Support Document for the Revised National Priorities List Final Rule – PROTECO

**Support Document for the
Revised National Priorities List
Final Rule
PROTECO
May 2019**

**Site Assessment and Remedy Decisions Branch
Office of Superfund Remediation and Technology Innovation
Office of Land and Emergency Management
U.S. Environmental Protection Agency
Washington, DC 20460**

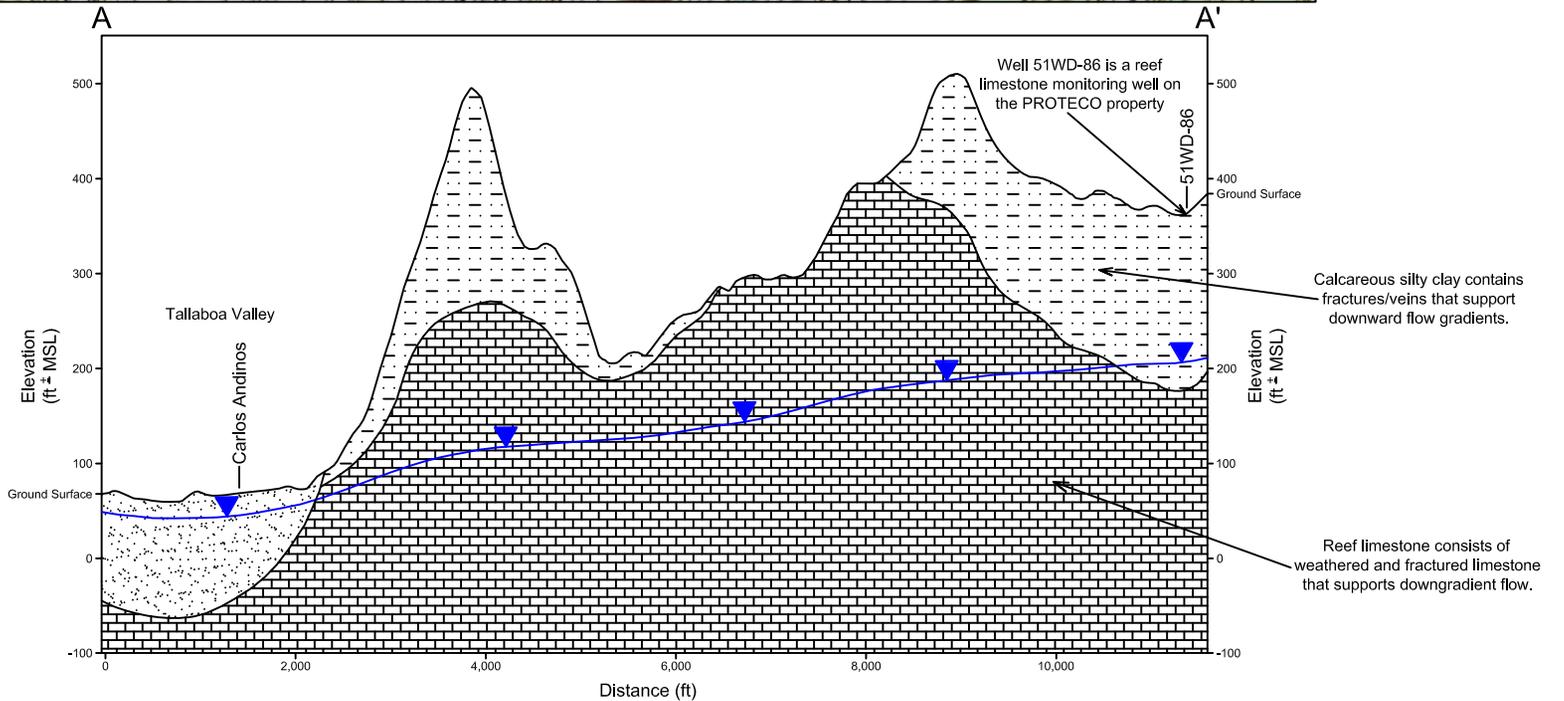
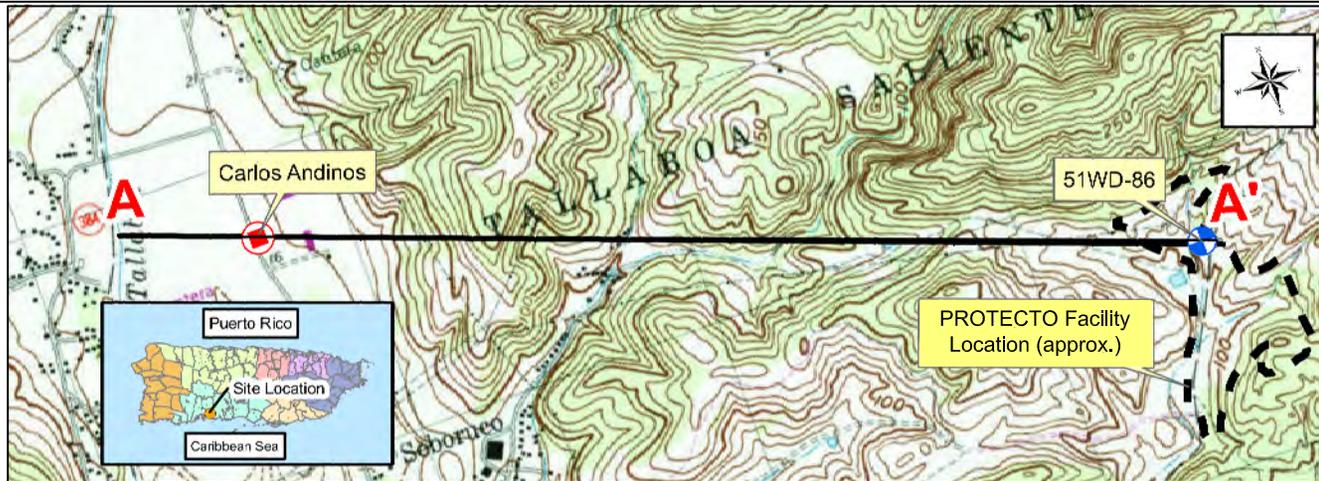
PVL and RMI both submitted comments questioning the interconnection of the Juana-Díaz and the Tallaboa aquifers within 2 miles of the Site. PVL commented that there is no data to support the EPA's assertion that wells constructed across an aquifer boundary (i.e., across the Juana Díaz and the Tallaboa aquifer boundary) lead to an interconnection between the two aquifers as noted in the HRS documentation record at proposal. RMI submitted numerous comments asserting that aquifer interconnections are not present and concluded there is no flow path between the groundwater associated with the PROTECO facility and that of the groundwater in the Tallaboa

The single hydrologic unit evaluated for HRS purposes includes four layers/formations. The hydrogeological conditions underlying the PROTECO facility consist of three interconnected aquifer layer/formations: these are the alluvial deposits starting at the surface, the upper Juana Díaz Formation (calcareous silty clay¹) below the alluvial aquifer, and below that the lower Juana Díaz Formation (reef limestone). The Tallaboa alluvial aquifer, while not present directly below the PROTECO facility, is an additional aquifer that is located approximately 1.5 miles west and approximately 300 feet lower in elevation than the PROTECO facility in the Tallaboa Valley (see Figure A-1 of this support document below). The Tallaboa alluvial aquifer consists of alluvial deposits of varying thicknesses (40-200 feet) that are recharged, at least in part, by the surrounding upgradient limestone formations, including the Juana Díaz Formation (See HRS documentation record figures 1-3, Reference 24, and Reference 27). Wells in the Tallaboa aquifer are also documented to be screened across multiple aquifer layers. For HRS purposes, all of these aquifers are documented to be interconnected within 2 miles of the Site sources and are considered one hydraulic unit.

Sampling of existing on-site monitoring wells from 1986 to 1994 indicates that VOC contamination has migrated to the upper water-bearing zone of alluvial deposits and calcareous silty clay underneath the Site, as well as the underlying reef limestone in the Ponce-Juana Díaz aquifer. The samples from on-site monitoring wells establish

FIGURE #: **A-1**

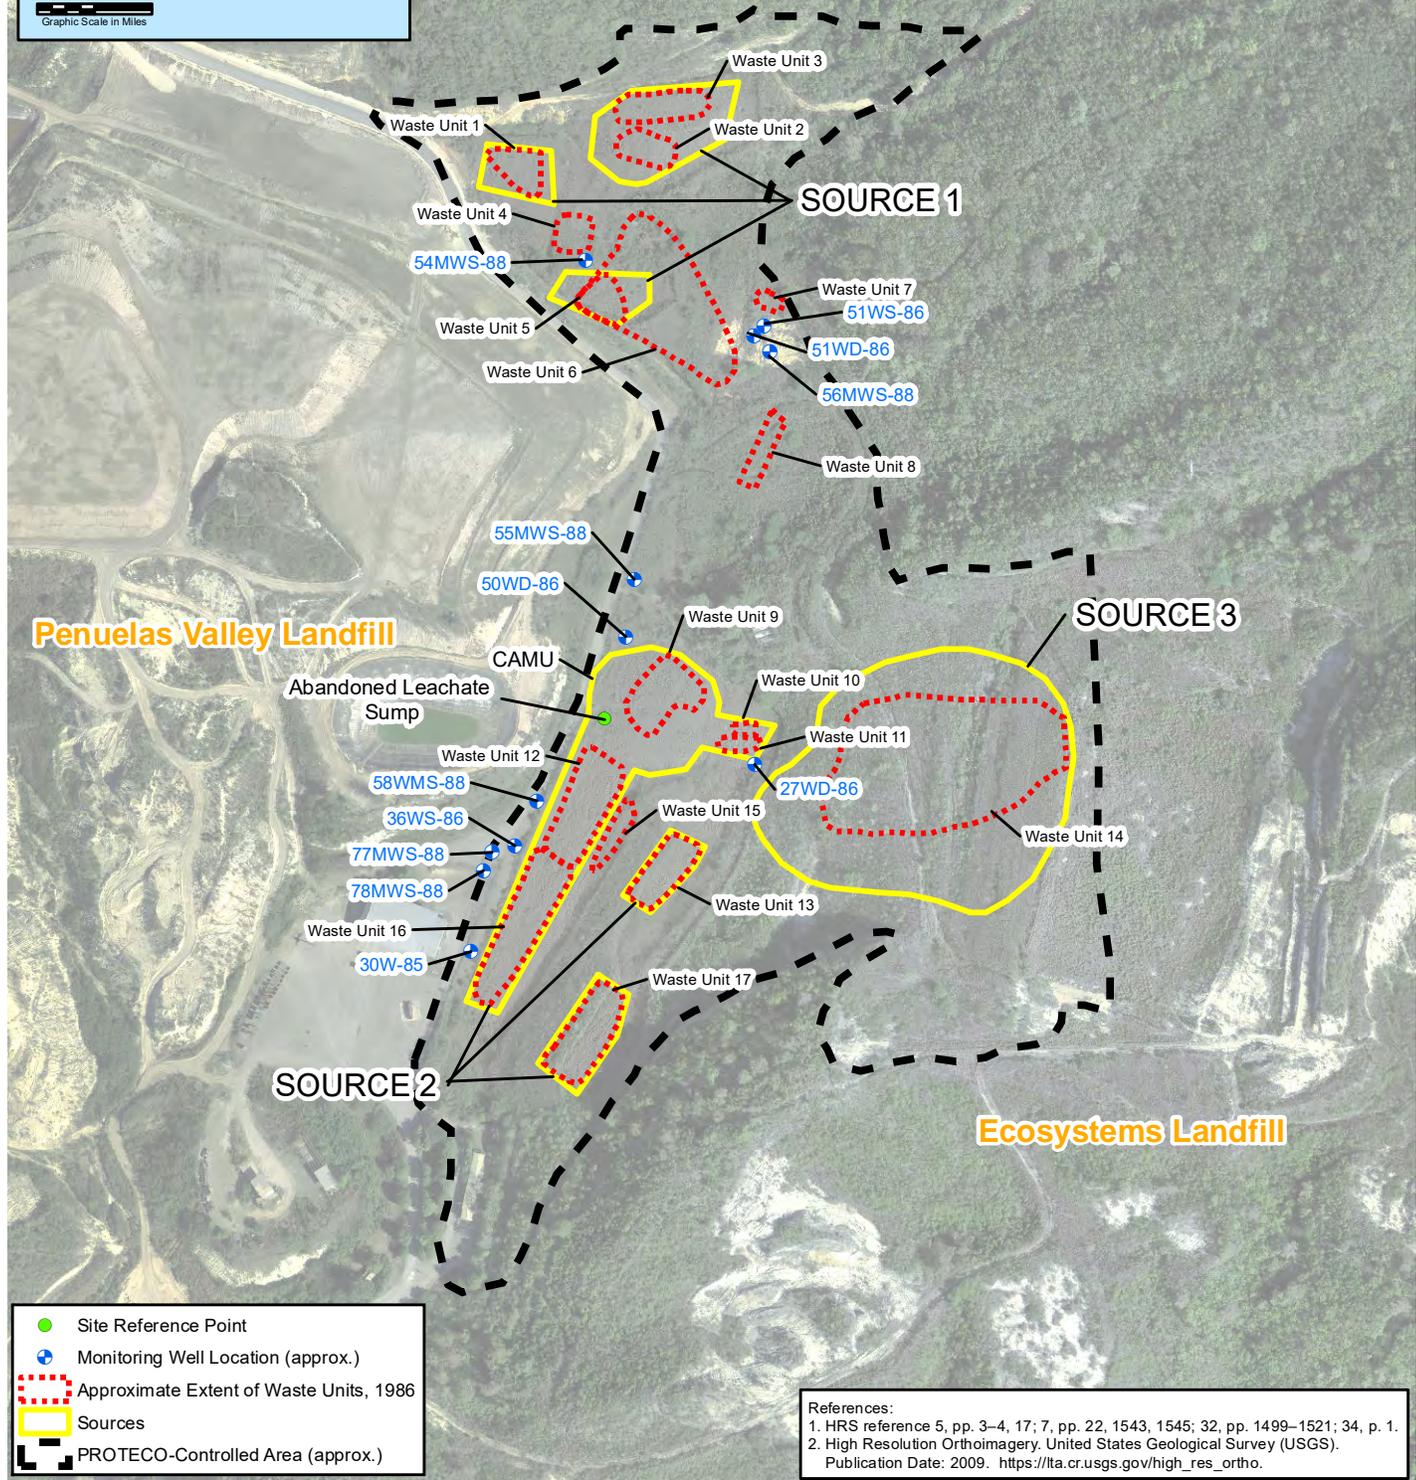
Comment: PVL and RMI both submitted comments questioning the interconnection of the Juana-Díaz and the Tallaboa aquifers within two miles of the Site. PVL commented that wells found at the Site have perched water with high specific conductance and stated that if there is a connection between the wells at the Site and those wells in the Tallaboa alluvial aquifer, one would expect higher specific conductance in the potable wells in the Tallaboa Valley. PVL commented that there is no data to support the EPA's assertion that wells constructed across an aquifer boundary (i.e., across the Juana Díaz and the Tallaboa aquifer boundary) lead to an interconnection between the two aquifers as noted in the HRS documentation record at proposal.

In questioning potential Site impacts to groundwater wells, RMI stated that “[o]n numerous occasions, RMI supported its contention that post closure groundwater monitoring at the site was unnecessary precisely because of prevalent groundwater conditions and aquifer interconnection.” In support of this, RMI cited an attachment to its comments, November 7, 2003, correspondence from Beveridge & Diamond, P.C. on behalf of PROTECO to EPA Region 2. This correspondence and attachments to it included assertions that aquifer interconnections are not present between the groundwater associated with the PROTECO facility and that of the groundwater in the Tallaboa Valley. These assertions include the following:

Response: The hydrogeological conditions at the Site are appropriately evaluated as presented in the HRS documentation record at proposal; and the Juana-Díaz aquifer underlying the facility was properly determined to be hydraulically interconnected to the alluvial Tallaboa aquifer. The EPA established interconnections, consistent with the HRS, within the alluvial and Juana-Díaz aquifer layers by documenting preferential pathways in the calcareous silty clay layer that allow groundwater to travel from the surface to the reef limestone, and documenting that contamination has been observed to migrate into the reef limestone from the above aquifer units. The EPA then documented that the reef limestone underlying the facility exhibits hydraulic gradients toward the west and northwest to the Tallaboa valley with no HRS-qualifying aquifer discontinuities identified between the aquifer units (see Figure A-1 of this support document). Therefore, the hydrogeological conditions were appropriately evaluated at the Site and it was determined that the aquifer units are hydrologically interconnected for HRS purposes.

Regarding this flow direction as it impacts the aquifer interconnection at the Site, the EPA does not challenge that the reef limestone has an overall dip toward the south or that the groundwater can flow to the south in the limestone; rather, the EPA notes that the fractured nature of the limestone allows for groundwater flow in many directions including toward the west/northwest as it was measured at the Site. Fractures in limestone provide a path of least resistance for groundwater to flow within a geological layer (i.e., fractures act as channels for groundwater flow in the subsurface). The EPA considers the overall orientation (the dip) of the geological layers, but the orientation is not the only consideration; at this site, fractures in the limestone must also be considered in the evaluation of the groundwater flow direction as fractures in limestone can have a greater influence on groundwater flow than the overall orientation of the geological layer. While the groundwater flow direction is discussed in greater detail below in section 3.13, Groundwater Flow Direction, of this support document, for purposes of interconnecting the reef limestone with the Tallaboa aquifer the EPA identified hydraulic gradients under the PROTECO facility flowing to the west/northwest along strike¹³ in the reef limestone toward the Tallaboa aquifer (see the quoted aquifer interconnection section of the HRS documentation record at proposal shown above in this response).

- Regarding the commenters’ discussion of an order of magnitude decrease in specific conductivity, total dissolved solids, chloride, sulfate, and sodium in the water between the reef limestone and the calcareous silty clay of the Juana-Díaz formation, and their conclusion that this indicates that the two layers are not hydraulically interconnected, this is not correct; these differences only imply that there is a greater quantity of conductive ions in the calcareous silty clay formation than in the limestone aquifer (or the downgradient Tallaboa alluvial aquifer). In general, specific conductivity refers to the amount of dissolved minerals/ions in the water. The assertion that the reef limestone formation has less dissolved minerals/ions than the upper calcareous silty clay layer is not an indication that the two layers cannot be interconnected; rather, it only indicates that the two layers have different chemical compositions and that the reef limestone layer may also be receiving additional input from other upgradient aquifers in addition to the calcareous silty clay aquifer. Additionally, as the calcareous silty clay layer contains gypsum veins (note that gypsum is a water-soluble mineral), it is expected that the water in this upper layer would have a higher specific conductance compared to the reef limestone layer.

More specifically, this difference in specific conductance does not show that groundwater cannot migrate down into the reef aquifer, it only indicates that calcareous silty clay formation groundwater might migrate down into the aquifer at a slower gradient (lower *hydraulic* conductivity) than that of other recharge points into the reef limestone. Even if preferential pathways were ignored as a conduit of vertical
